Re: Commercial Planned Unit Development #20-13034 (Meridian Mall Limited Partnership)

To: Planning Commission

Re: Commercial Planned Unit Development #20-13034 (Meridian Mall Limited Partnership)

Subject: **Meridian Mall Bank Traffic Impact Assessment**
Meridian Charter Township, MI

EXHIBIT 5
CONCEPTUAL SITE PLAN

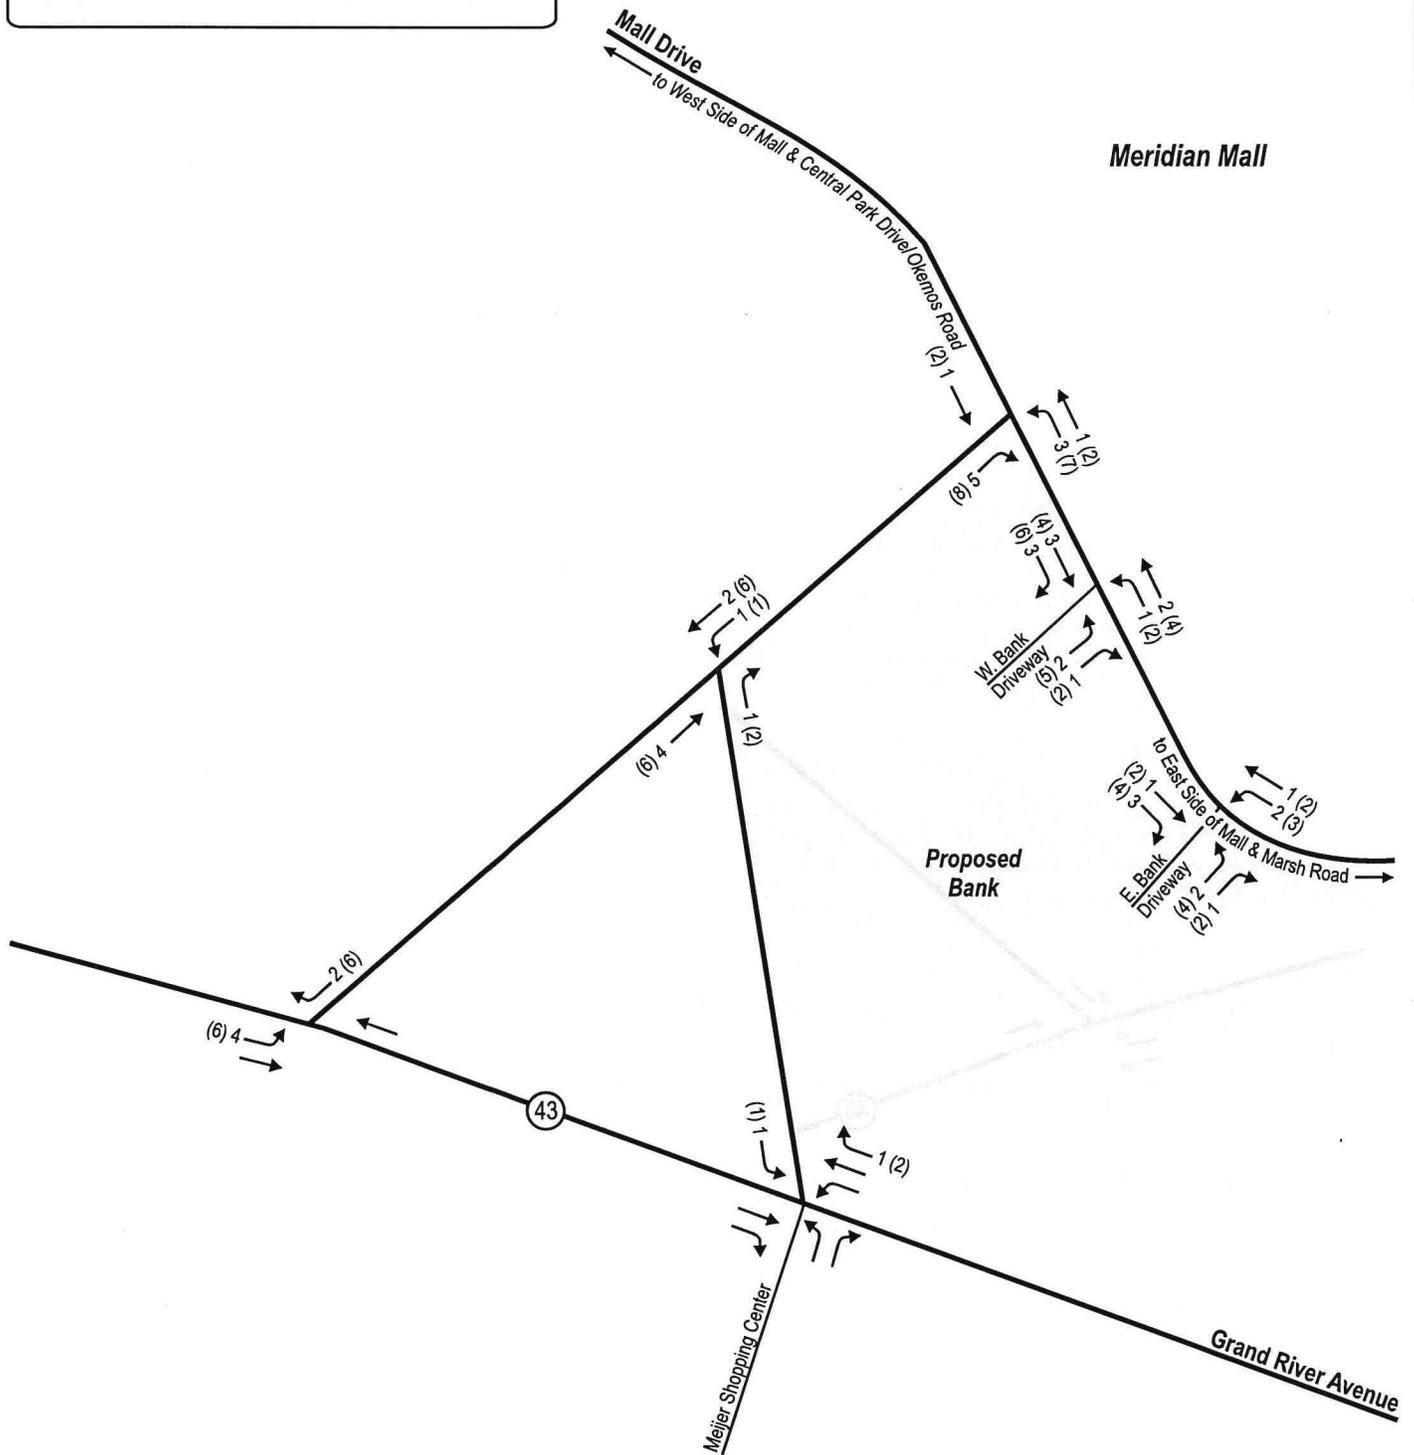
A vehicle bypass lane is required along the outside of the drive through lanes. The submitted site plan shows three drive through lanes with no bypass lane and is therefore requesting a waiver to have no bypass lane.

Sheet 8 of the submitted site plan shows the proposed amenities for the project, including connection to the pedestrian-bicycle pathway along Grand River.
